Rezoning Transportation Analysis

Petition Number: 2019-168

From: Felix Obregon, PE
fobregon@charlottenc.gov
704-432-5729

Reviewer: Eric Lemieux, PE
eric.lemieux@charlottenc.gov
704-336-2683

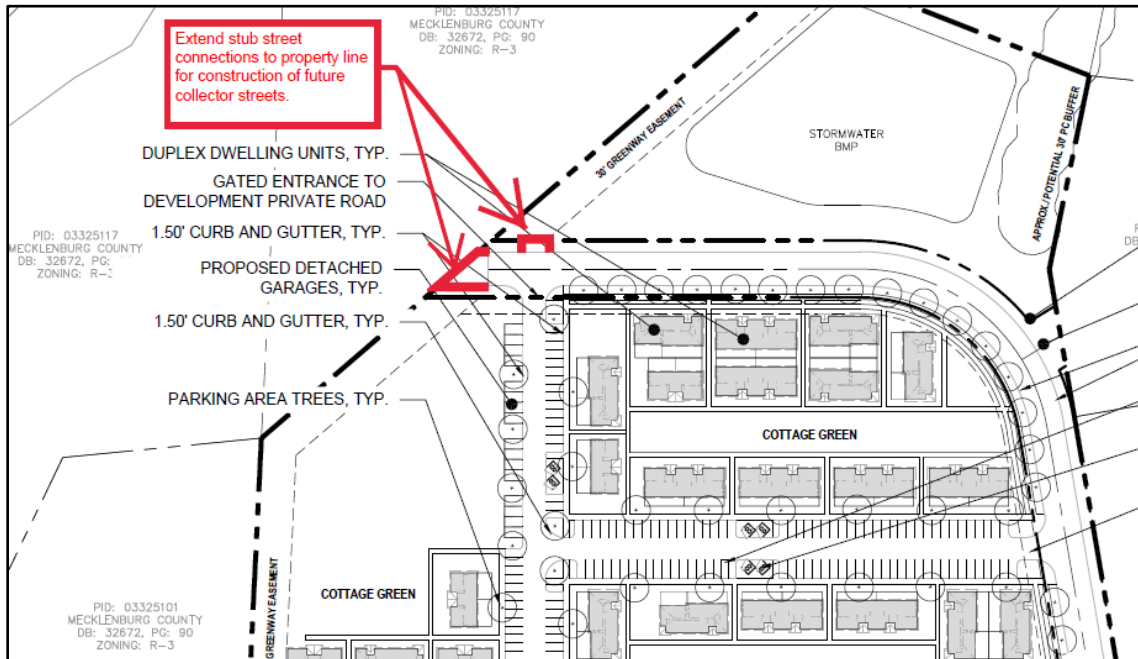
1. ~~**Curblines**~~ The proposed zoning district has a setback measured from back of the existing or proposed future curblines.
 - ~~**Oakdale Road (NCDOT maintained):**~~ The future location of curb and gutter is for a three-lane section. The face of the curb and gutter should be located 18.5' from center line of the road.
 - The site plan should show the curb and gutter labeled and dimensioned from the centerline for each road.

3. ~~Oakdale Road~~ is an existing minor thoroughfare. According to CRTPO, a minor thoroughfare requires 70-foot of right-of-way. The petitioner should revise the site plan and conditional note(s) to commit to dedicate 35-foot right-of-way from the road centerline. The site plan should label and dimension the right-of-way from the road centerline.

4. ~~Updated based on site plan (1/14/2020)~~ The proposed Collector Street included in the plan should be in accordance with the current Charlotte Land Development Standards for a local collector, [U-07-REV 17](#). The collector street should have a similar alignment to the original site plan.

5. Per Chapter 20 Subdivision ordinance, the petitioner should revise the site plan and conditional note(s) to commit to construct stub connections to extend to the property line for construction of future collector streets.

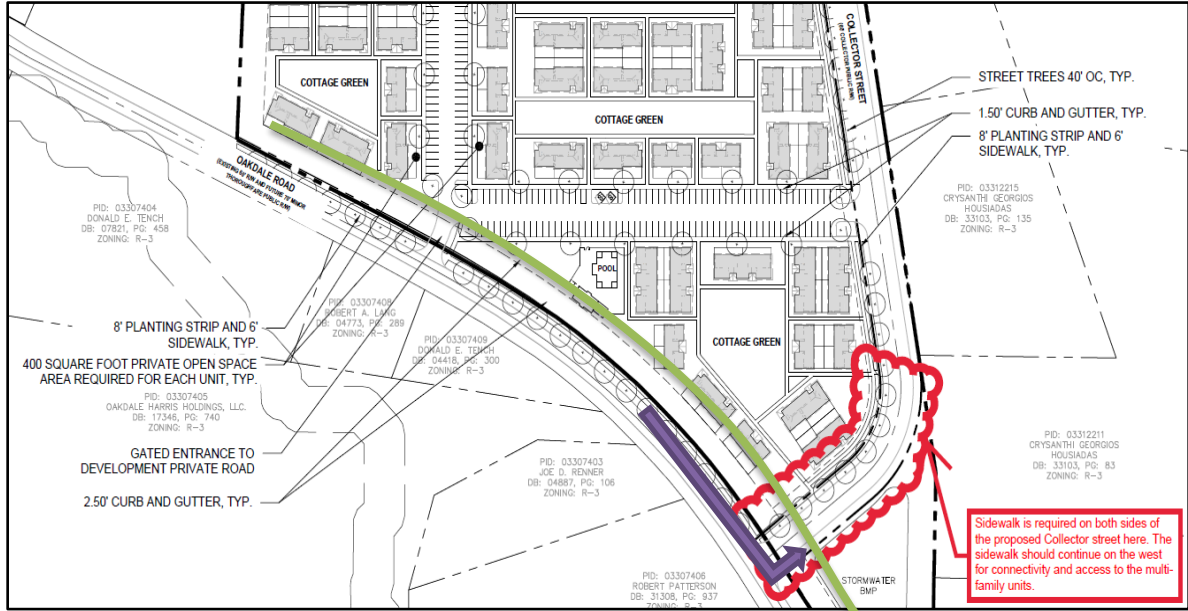
7. ~~To comply with the council adopted Charlotte Walks and BIKE Policy, CDOT is requesting the petitioner construct a 12-foot multi-use path along the Oakdale road. See multi-use path shown above in green.~~

8. ~~Per NCDOT, the petitioner should revise the site plan and conditional note(s) to include an eastbound left turn lane from Oakdale onto the proposed Collector street. See left turn lane shown above in purple.~~

9. ~~The petitioner should revise the site plan and conditional note(s) to commit to construct a left turn for each access point on Oakdale Road to create a three-lane section along the site's frontage in order to mitigate for the additional traffic it will create on a thoroughfare road.~~

10. ~~Per NCDOT, the proposed driveway stem length should be extended to 100' to ensure proper circulation of traffic and mitigate queuing onto Oakdale Road. In addition, if a gate will be provided, then a turnaround should be provided to the access to Oakdale Road because of the road traffic.~~

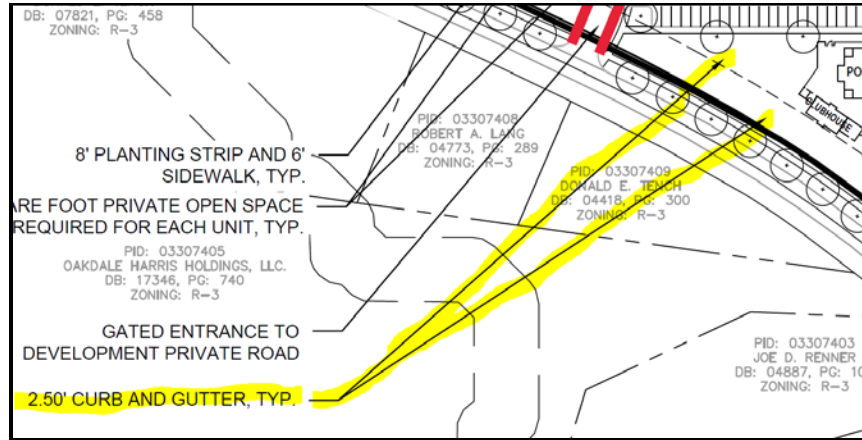
- ~~11. The petitioner should revise the site plan and conditional notes to correctly show label the curb and gutter locations on the site plan. The site plan is showing a label of curb and gutter that is pointing to where there is not curb and gutter.~~

- ~~12. The petitioner should revise the site plan and conditional notes to provide a minimum of 40 feet (vehicle length) must be provided between the card reader and the street right of way, setback line, or back of sidewalk, whichever is greater. This will avoid vehicular conflict between pedestrians along the local road.~~

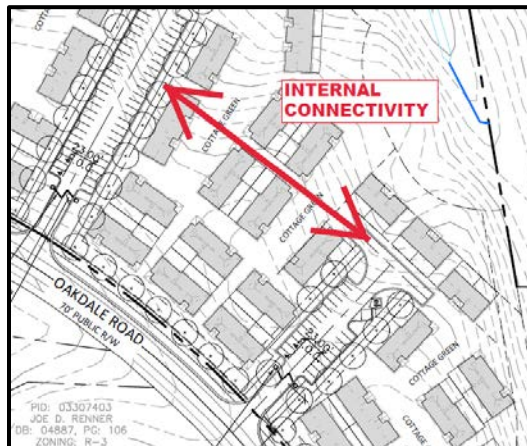
- ~~16. Revised site plan based on site plan (1/14/2020) The petitioner should revise the site plan and conditional notes to commit to provide internal vehicular connectivity between the different internal private streets.~~

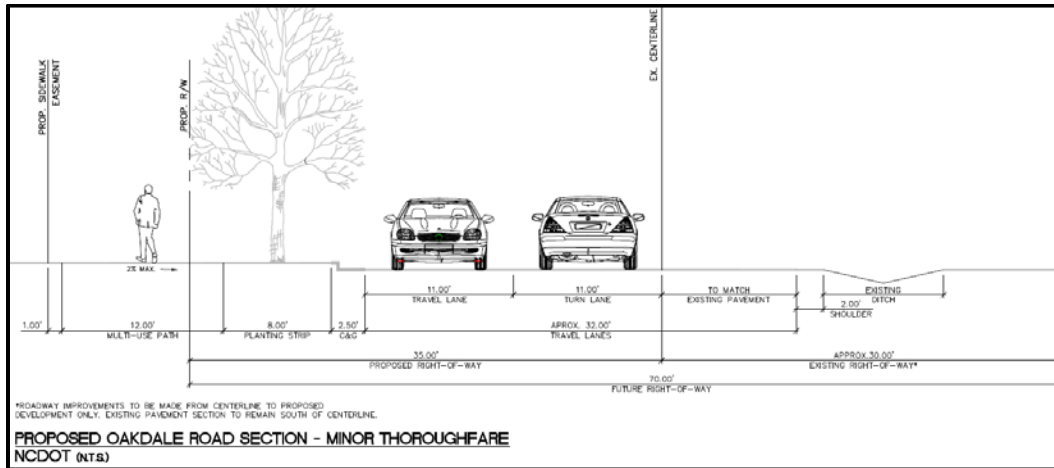
- 17. ~~New Comment based on revise site plan (1/14/2020)~~ The petitioner should revise the site plan and conditional note(s) to eliminate the internal gates and/or provide a turnaround at each private drive. If gates will be kept, a 75' stem is needed prior to the gates with a turnaround.
- 18. ~~New Comment based on revised site plan (1/14/2020)~~ The petitioner should revise the site plan and conditional note(s) to provide an exhibit showing the Oakland Road roadway improvements and the NCDOT roundabout project to make sure they overlap with each other, and there isn't a conflict.
- 19. ~~New Comment based on revised site plan (2/11/2020)~~ The petitioner should revise the site plan and conditional plans to show the curb and gutter be a consistent distance across the entire frontage, instead of tapering at the property line, as per the typical provided for Oakdale Road Section.

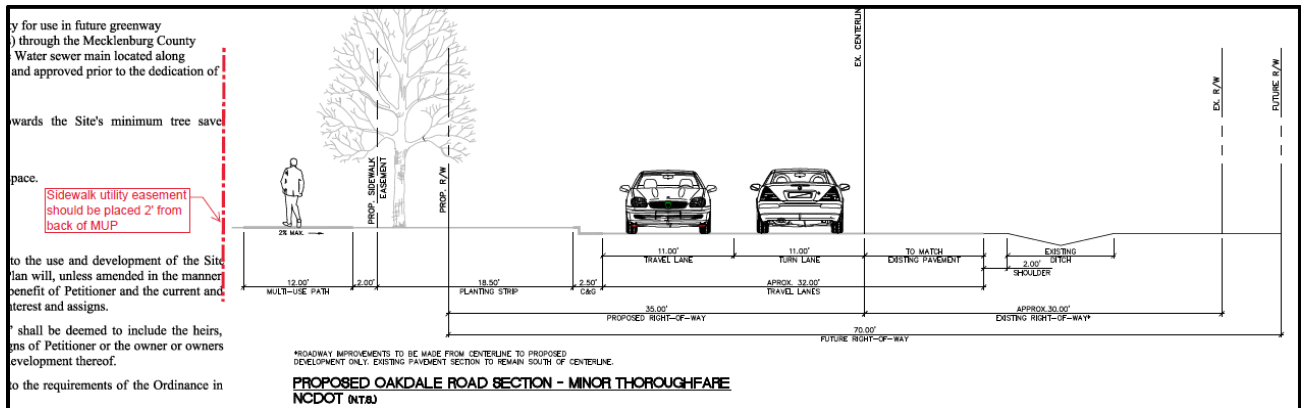
- a. **Technical Clarification based on revised site plan (5/12/2020)** The petitioner should revise the proposed Oakdale Road cross section to relocate the multi-use path (MUP) sidewalk easement to 2-feet from back-of-MUP.

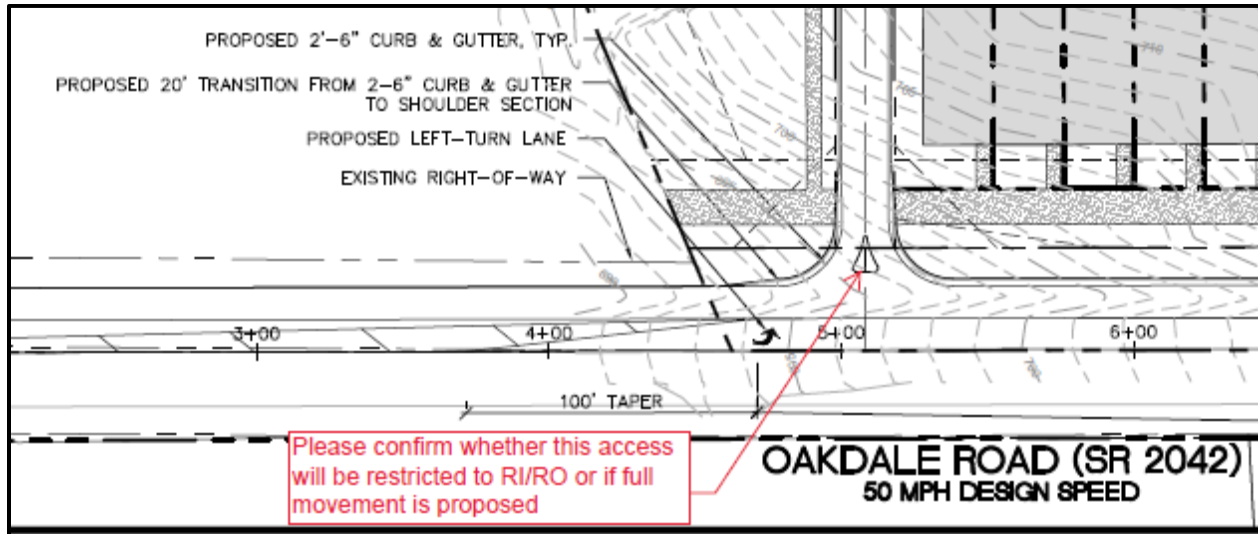
- 20. **Technical Clarification based on revised site plan (5/12/2020)** The petitioner should revise the site plan and conditional note(s) to clarify that the proposed access below will be reviewed and considered by NCDOT, during plan permitting, as either full movement or right-in/right-out. A right-in/right-out access will only be permitted if a center median is installed. If full movement, NCDOT may require the storage and taper length of the Oakdale Road left-turn lane to be extended. A detailed review will be completed during permitting.
